File No. 93004-1

October 11, 1996

Ref: **Maintenance Inspection**
Poldervaart-Webster Municipal Drain

ROLDERVANKI - WEBSTER
MUNICIPAL DRAIN
#93004-1.
REF: CONSENTS 8-35, 86, 37/45
J. RESTI.

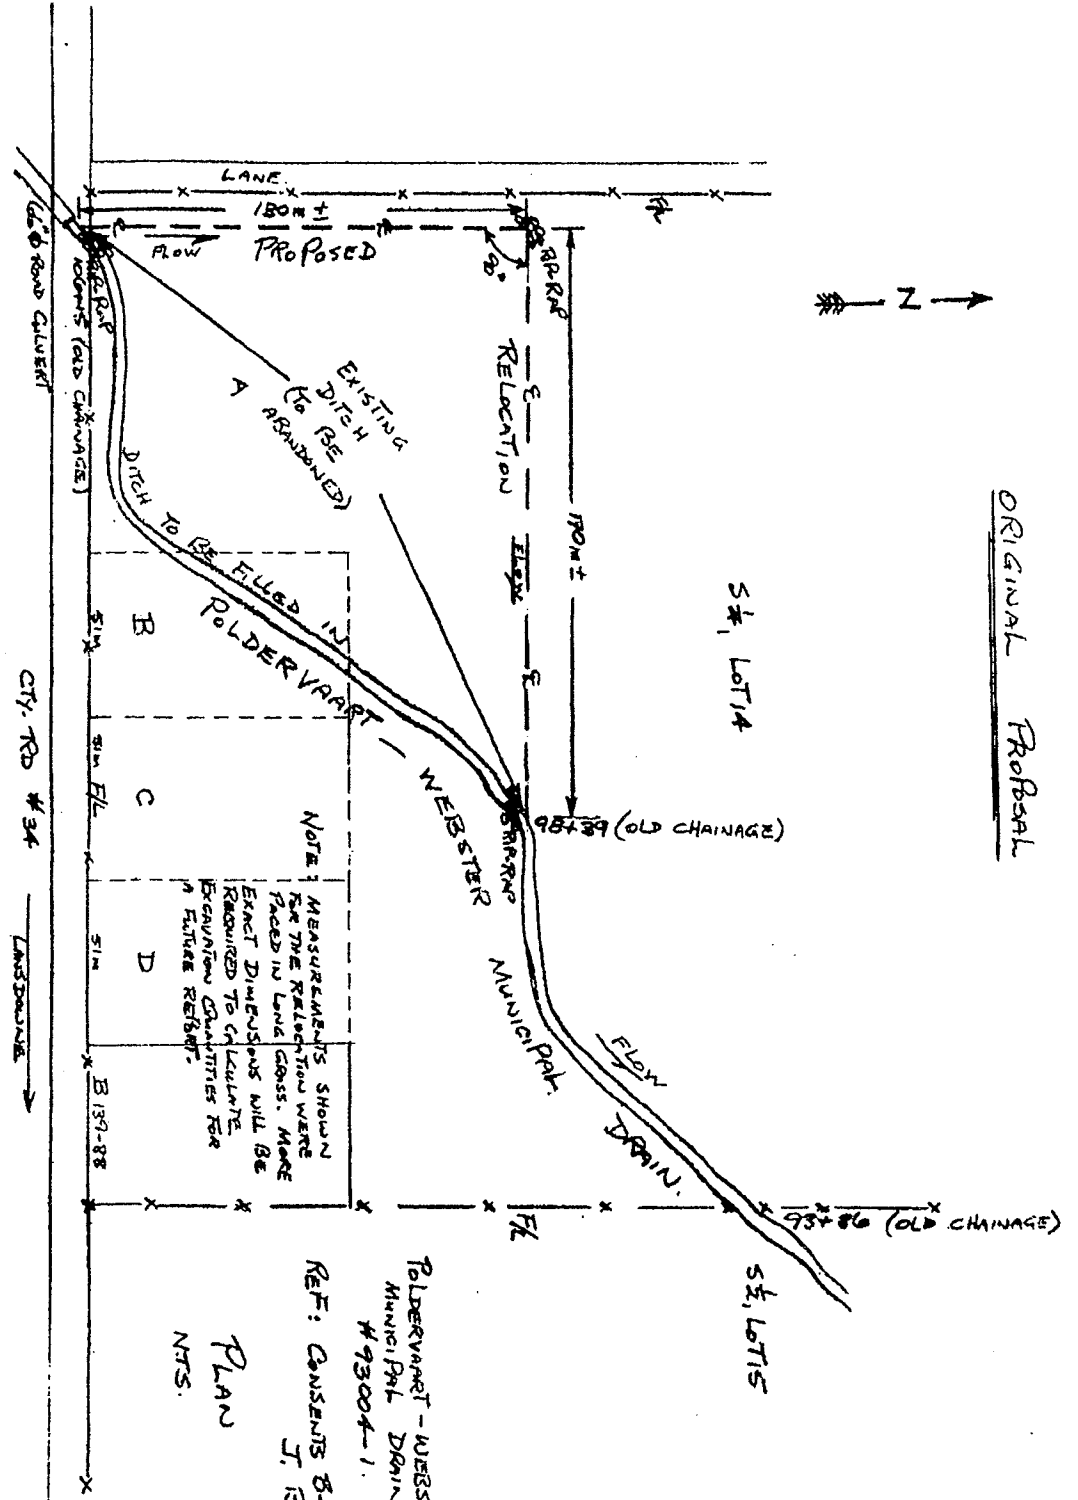
After finishing with Mr. Poldervaart, our inspector moved to the north side of the County Rd to check the ditch outletting from the Road Culvert. From Sta. 106+15 to Sta. 93+86 we found that the owner, J. Best S 1/4, 14 Conc 3 has proceeded on his own to maintain the ditch. He has also relocated part of the drain as shown on the attached drawings. As far as we know permission was not given either by Council or the Drainage Superintendent. However, the ditching has been well done and provides an excellent outlet for the lands south of the County Rd.

The access culvert installed as shown in the drawings is not acceptable. It is an old water boiler with the ends removed. During installation the downstream end of the culvert was badly damaged. Being an access crossing we would recommend a 60" (1500 mm) dia culvert be installed. Rip-rap with filter cloth is required at the junctions of the relocated ditch and filled in channels.

The new relocation involves only about $1/3 \pm$ of the existing channel. The remaining $2/3 \pm$ was excavated in the usual maintenance fashion. The new relocated channel is more cost effective than the one shown on the Consents B-35, 36, 37/95. We would recommend that the people involved with the above consents be advised of the revised alignment.
